CITY OF ALBUQUERQUE

RE: **Taos II @ The Trails**
Grading and Drainage Plan & Report
Stamp Date 7-13-16 (File:C09D00G1)

Based upon the information provided in your submittal received 7-14-2016, the above referenced Grading and Drainage Plan & Report is approved for Preliminary Plat with the following conditions:

DRAINAGE REPORT FOR TAOS II AT THE TRAILS SUBDIVISION

TAOS II AT THE TRAILS
GRADING PLAN

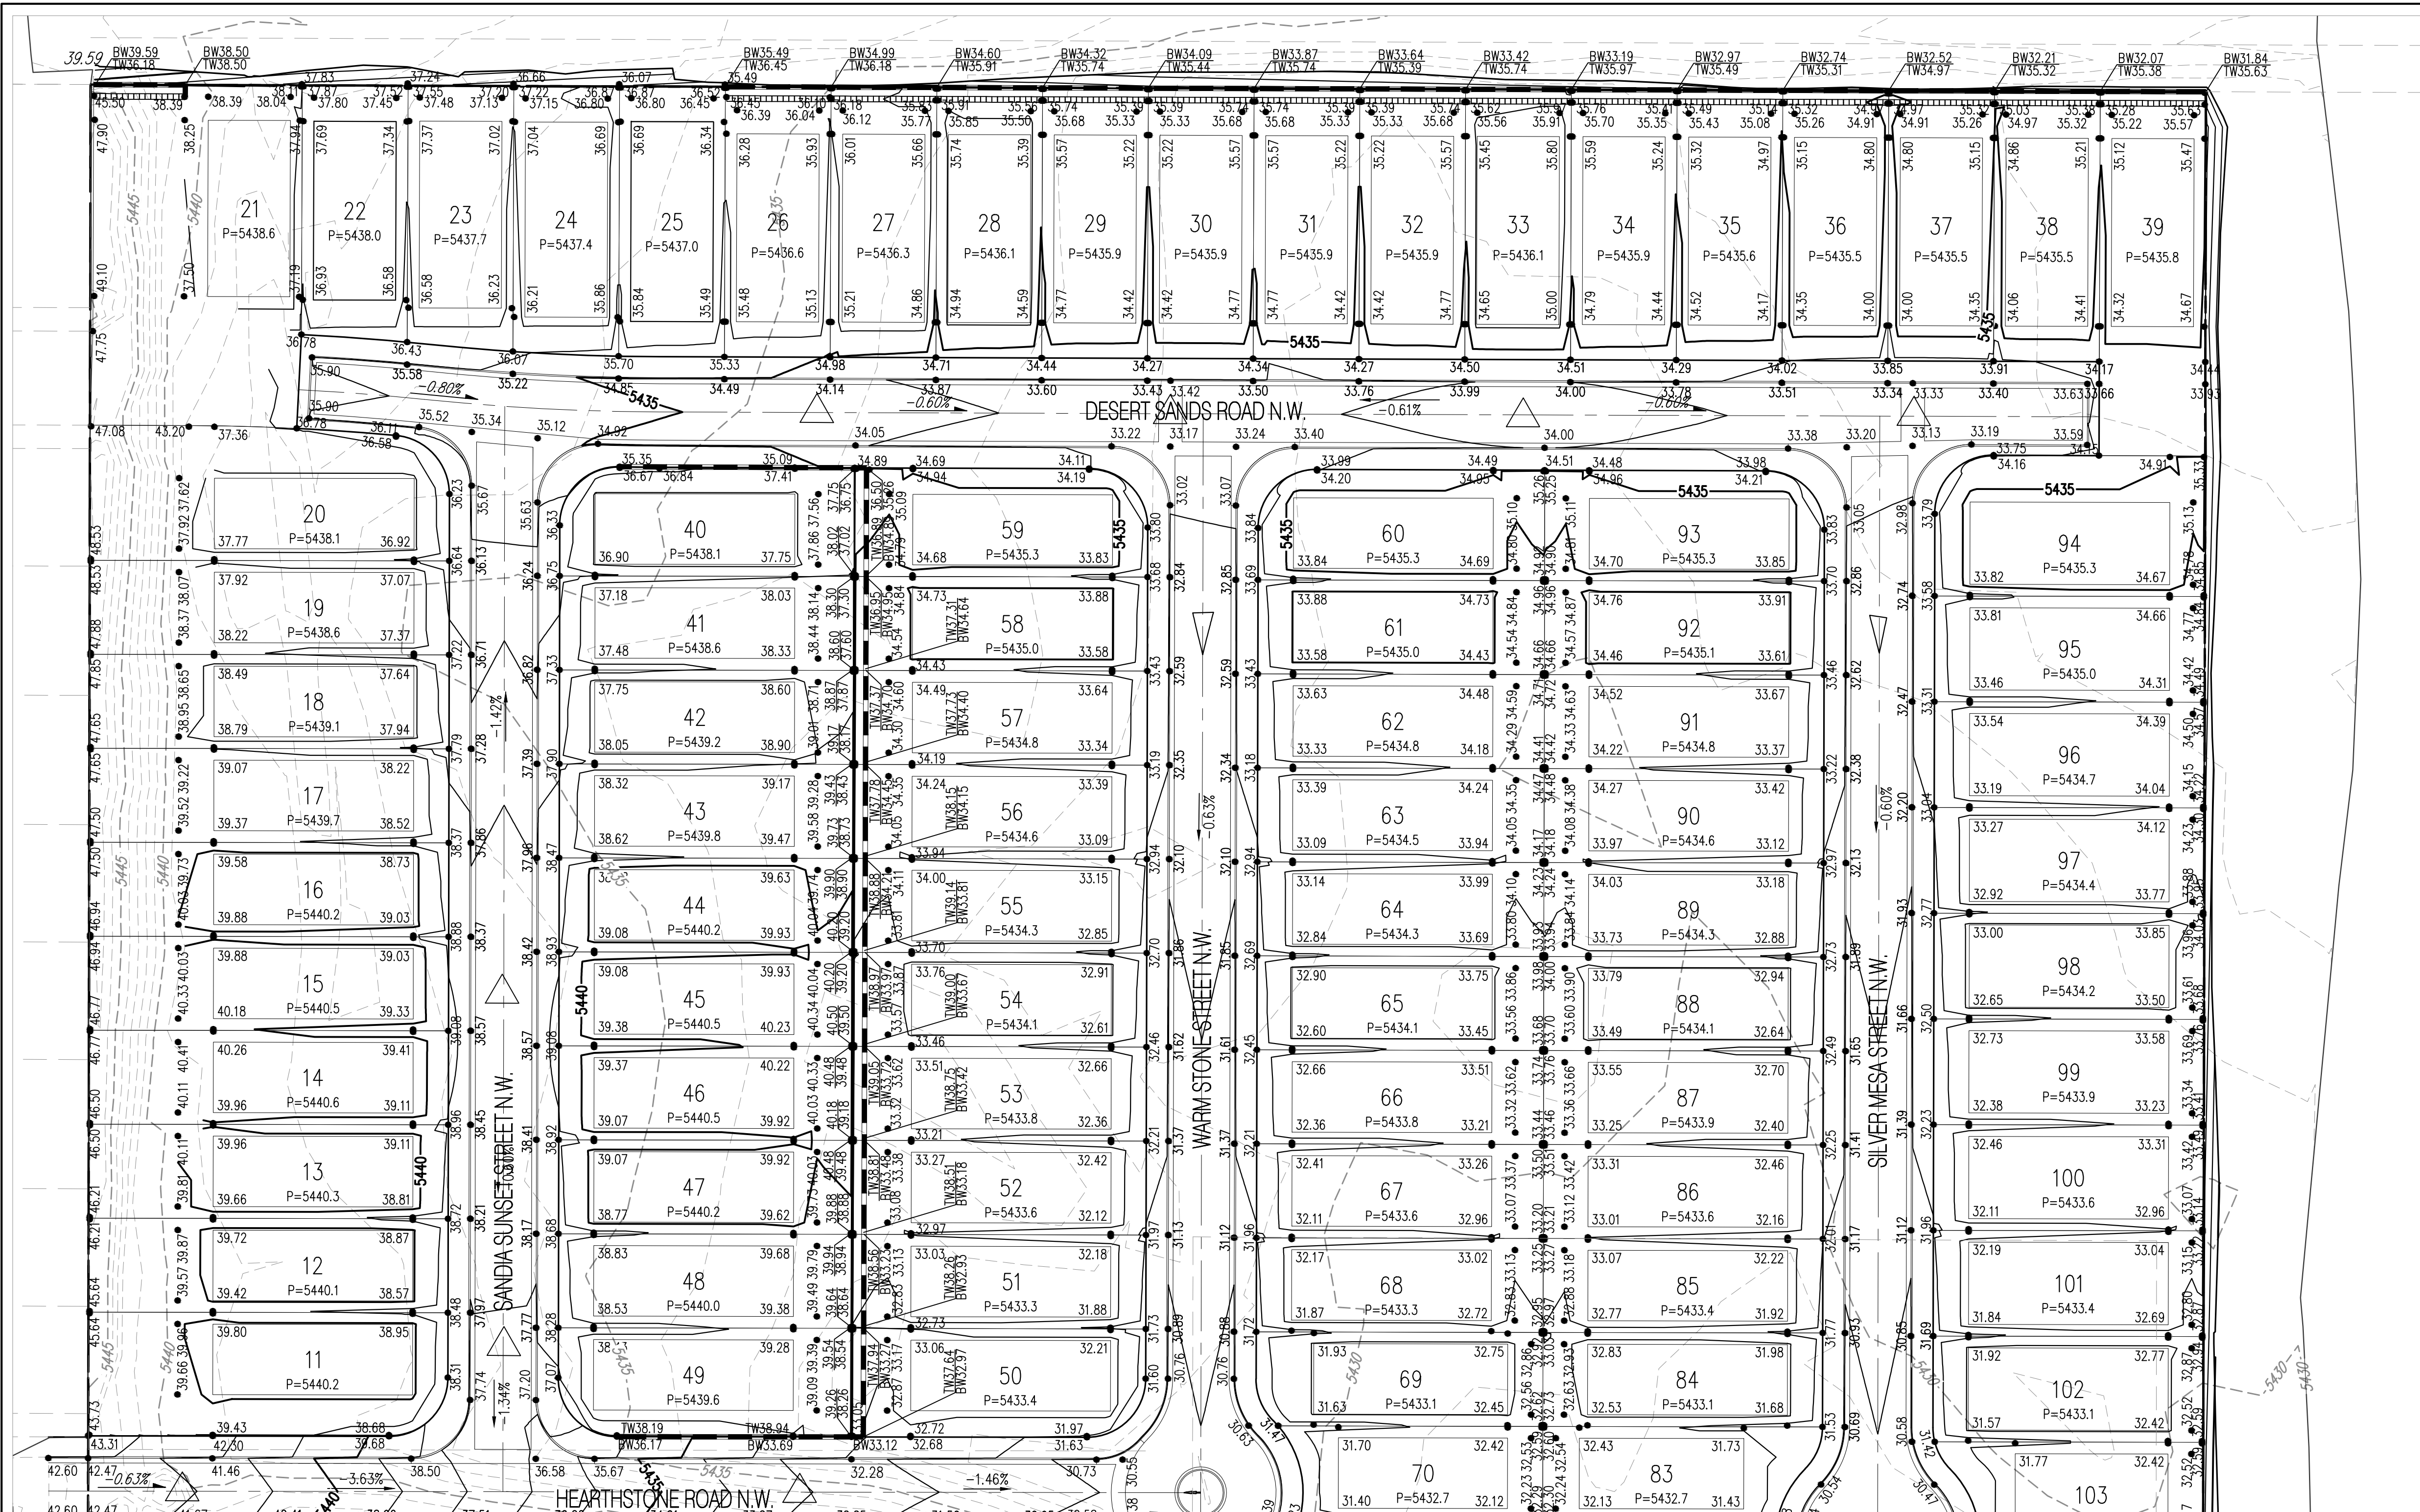
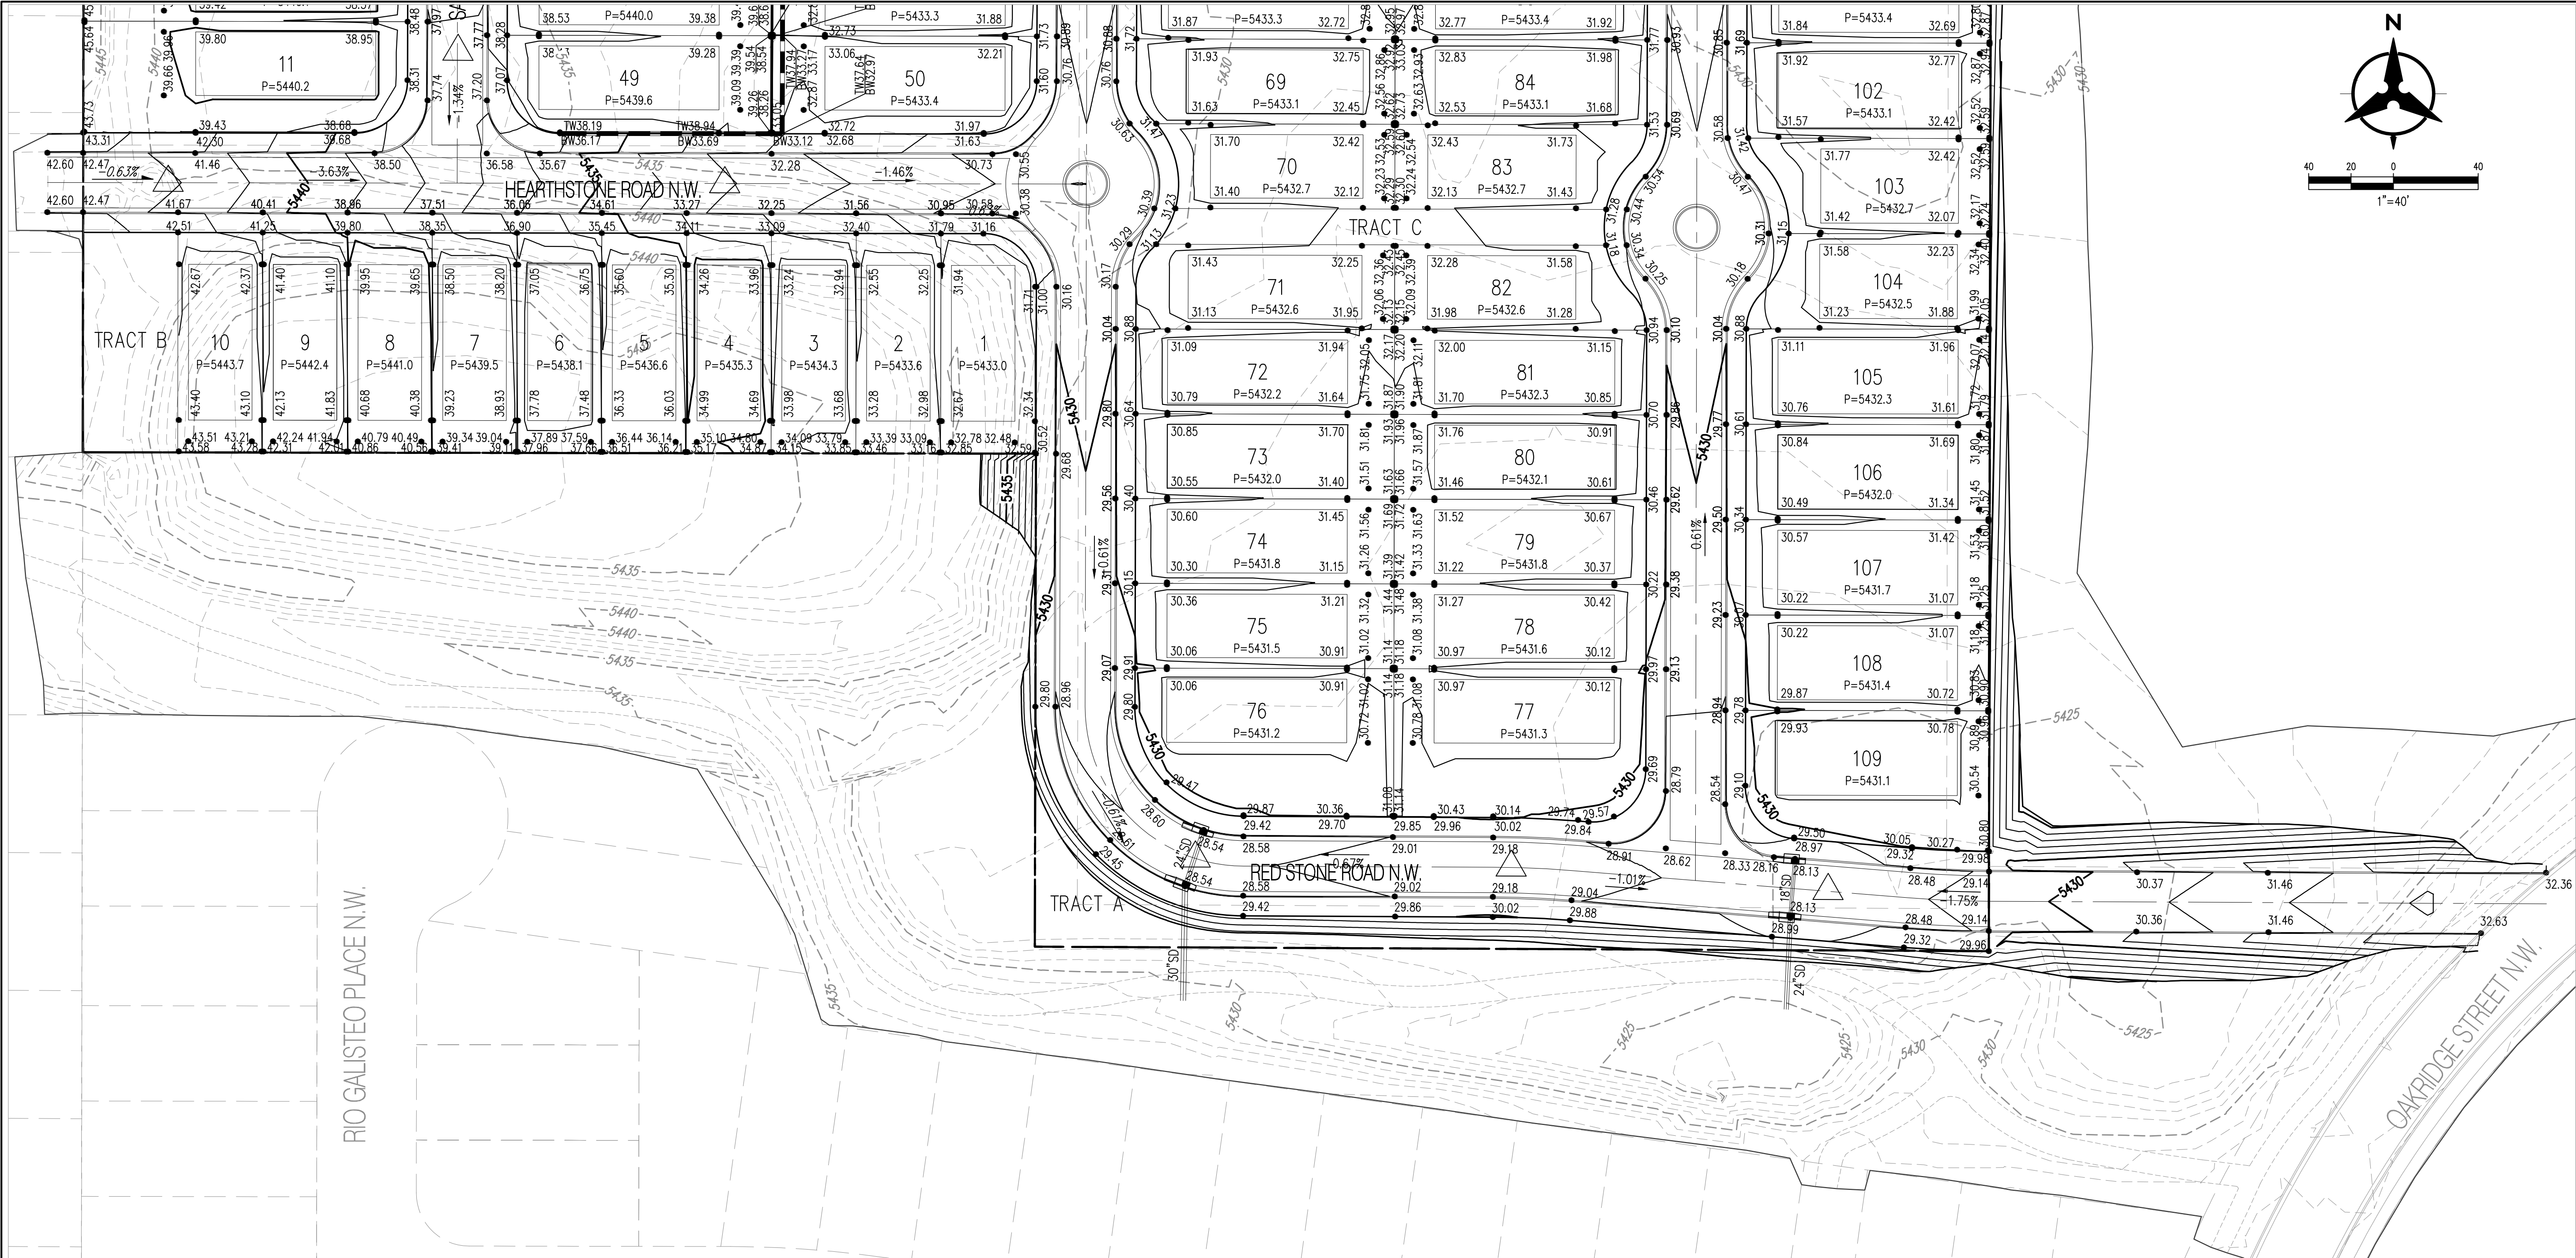
1. Consolidate the discrepancy with the allowable discharge as described by the Update to the Amendment to the Drainage Master Plan, by RESPEC and Thompson Engineering, dated 9-14-2016. The allowable discharge on Table 7 is approximately 52 cfs, and the subdivision is proposed to discharge approximately 58 cfs. Although the discrepancy might not be significant, Pond F5, (the outfall for Taos II), will not have much freeboard to work with.

2. The improvements referenced on the Infrastructure List need to be shown on the Grading Plan:
 - a. The Improvements related to Ponds F, F5 and D. The orifice plate can be included by reference or as a specific note/exhibit of the improvements required.
 - b. The outfall conditions into Pond F5. Note that the Drainage Master Plan elevations are based on NGVD 29 datum.
3. It is not clear where the wall drain detail will be used since it appears that all lots drain to the roadway. Any planned rear-lot ponding would require an easement.
4. An approved ESC Plan will be required.
